Preliminary Plan For Terakee Village 2

A part of the Northwest Quarter of Section 21, T6N, R2W, SLB&M, U.S. Survey

16N719-Prelim-New-1

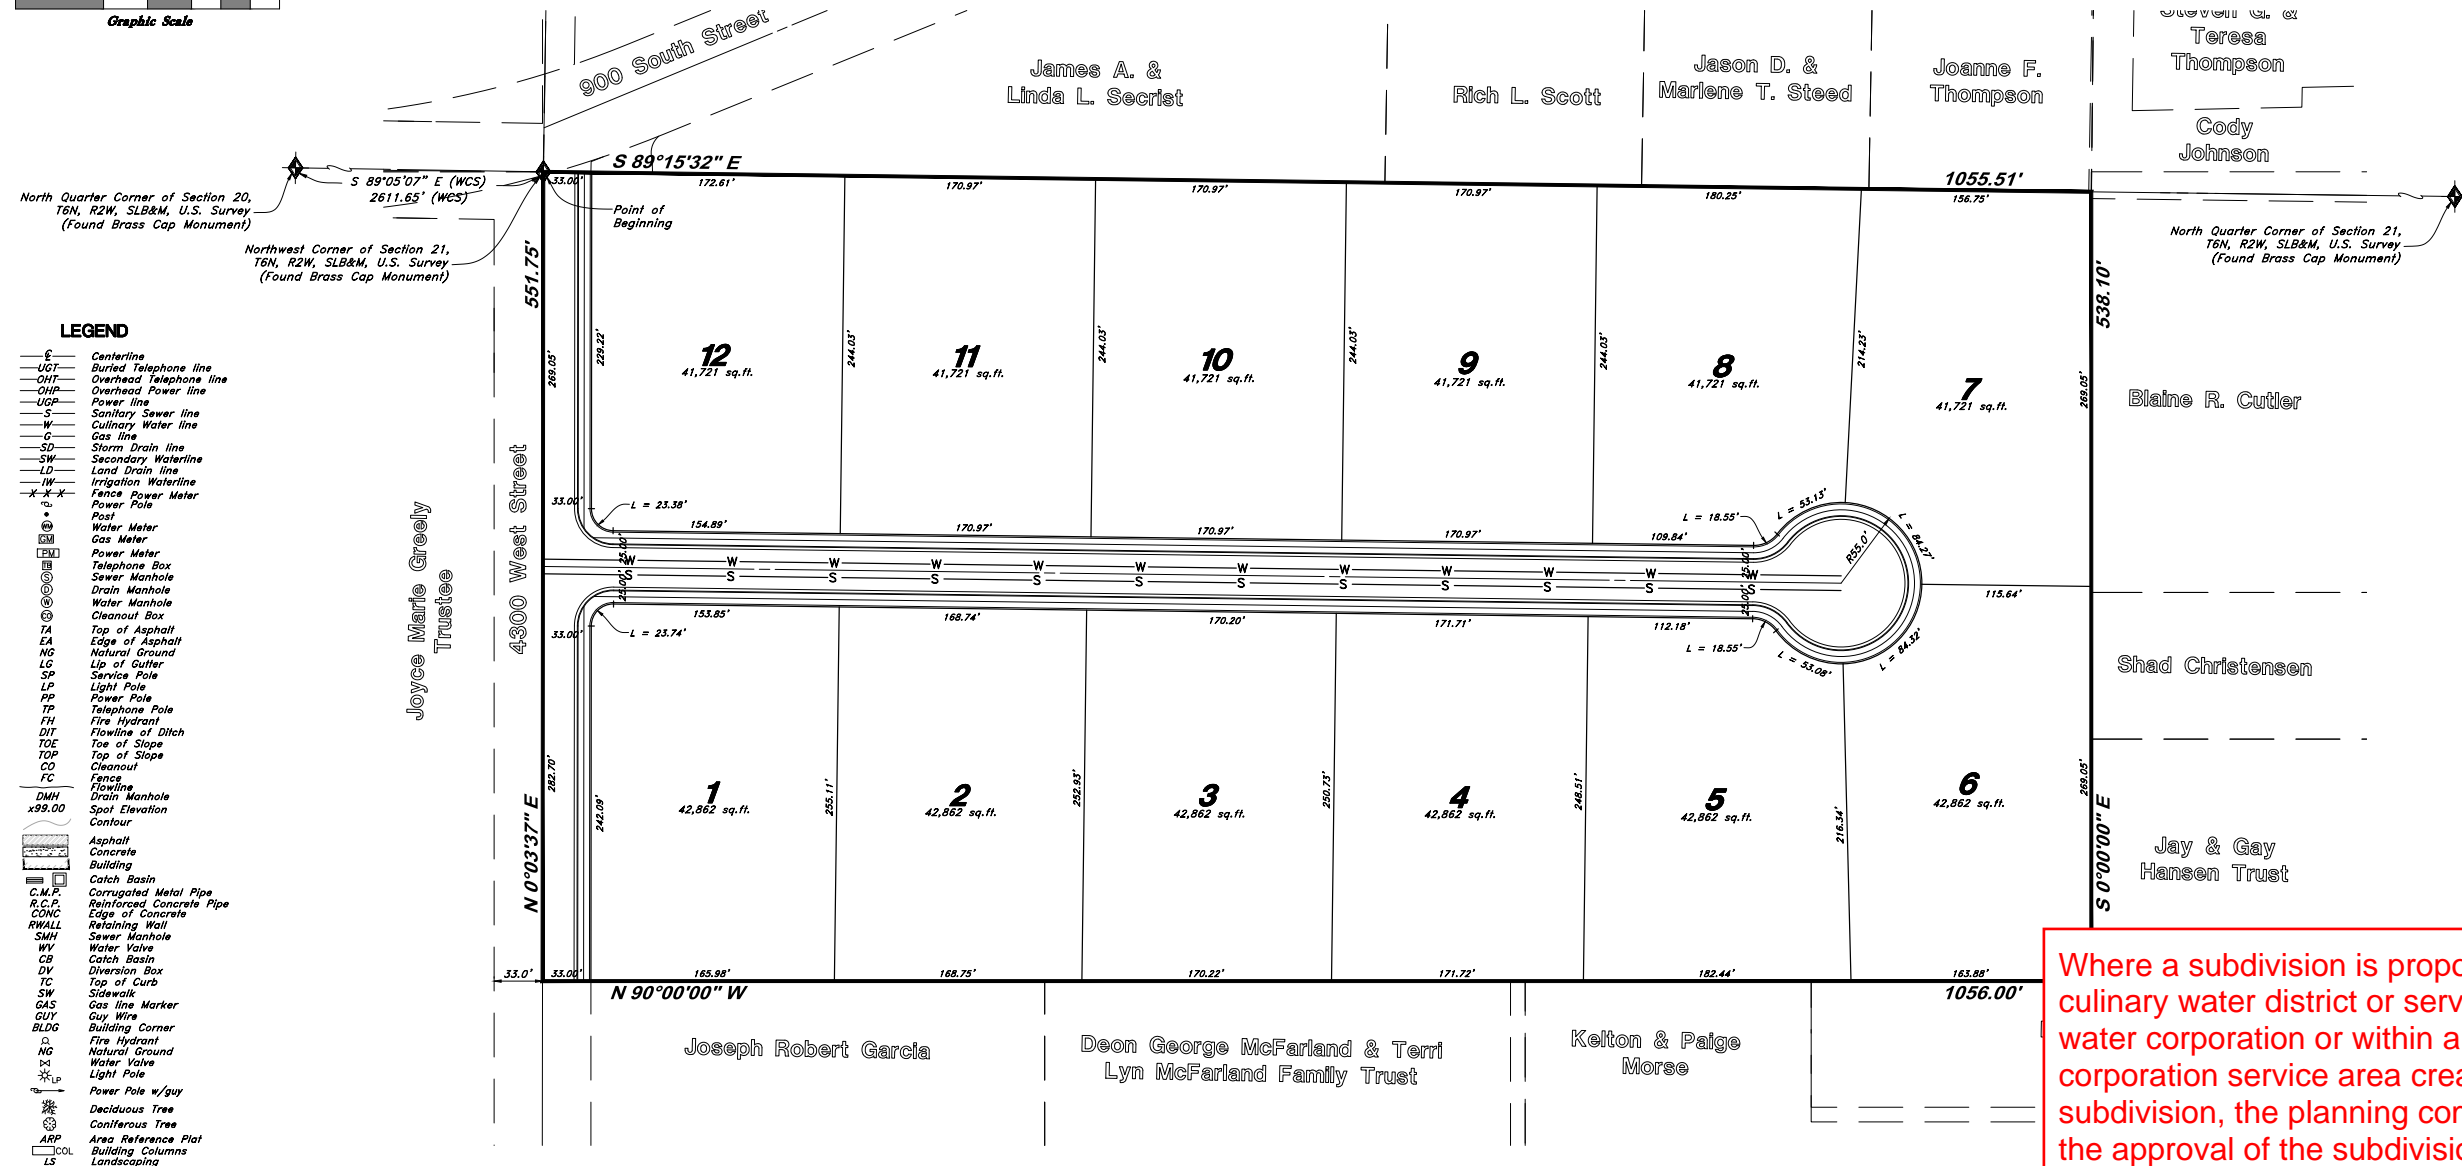
As a preliminary subdivision requirement, the location of wetlands must be identified. LUC 106-1-5a(6).

Where a subdivision is proposed within an existing culinary water district or service area of an existing water corporation or within a water district or water corporation service area created to serve such subdivision, the planning commission shall, as part of the approval of the subdivision, require the applicant to furnish adequate secondary water and install a secondary water delivery system to the lots in the subdivision sufficient to conform to the public works standards. LUC 106-4-2 (m)

STANDARD RURAL ROADWAY SECTION

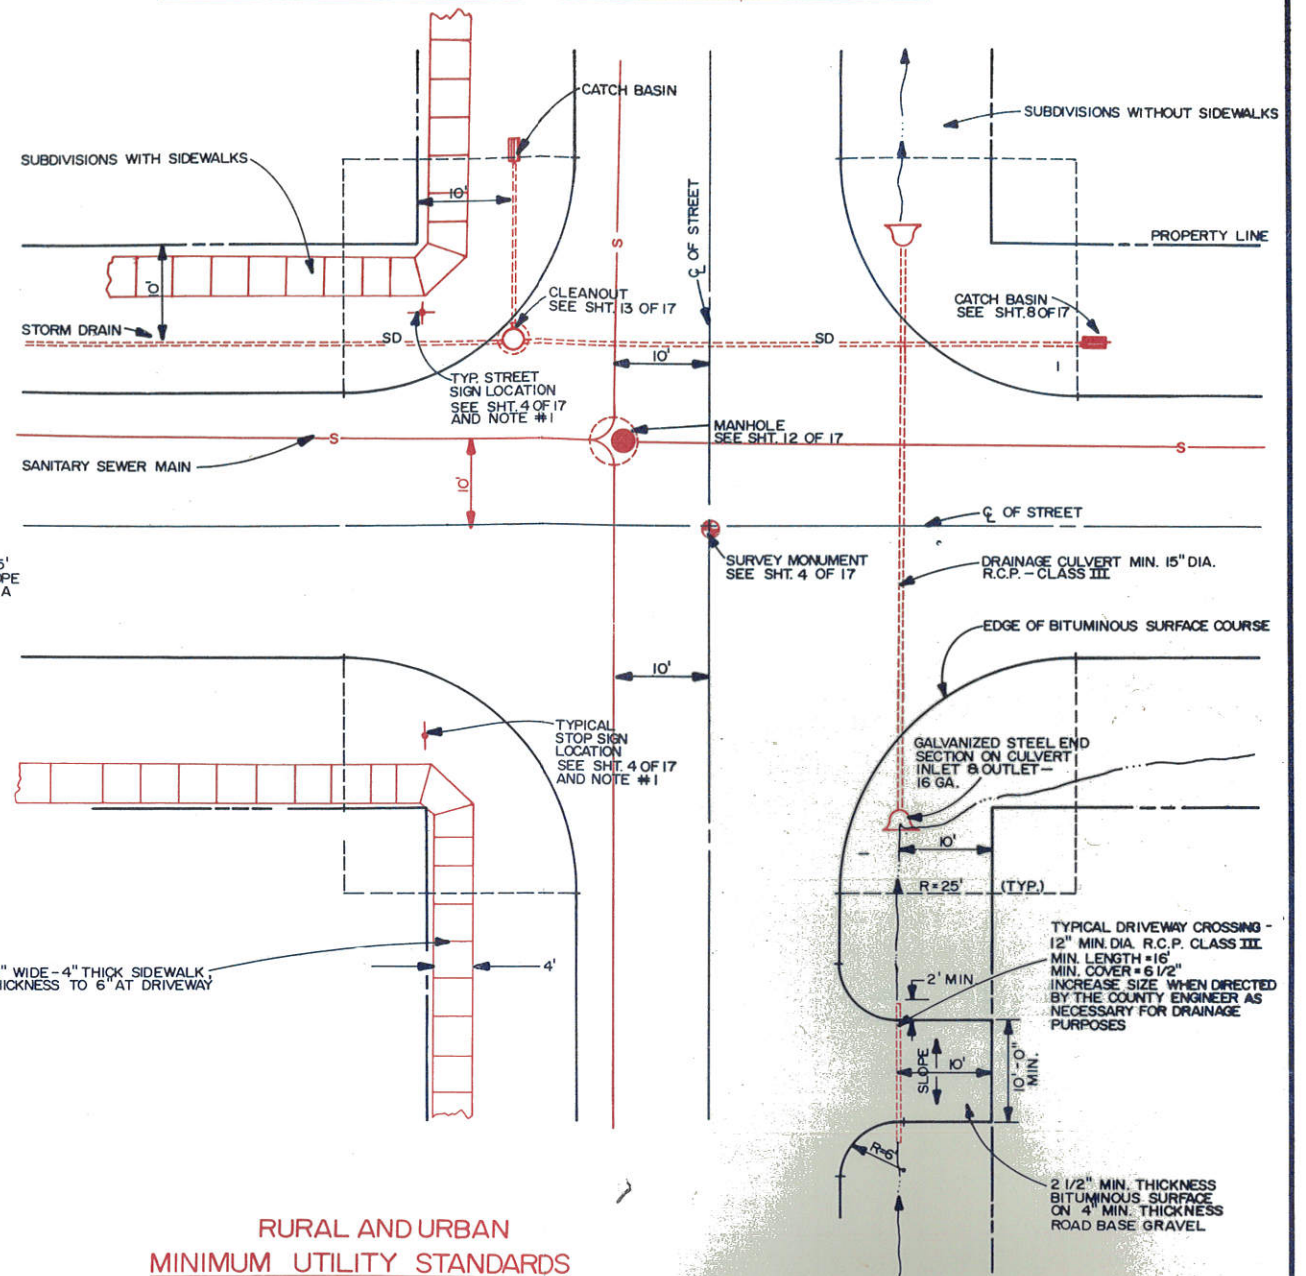
Sidewalk is required by the county.

Sidewalks shall be required by the planning commission for reasons of safety and public welfare, and where the proposed subdivision is located within the walking distance established by the local school district. LUC 106-4-2(f).
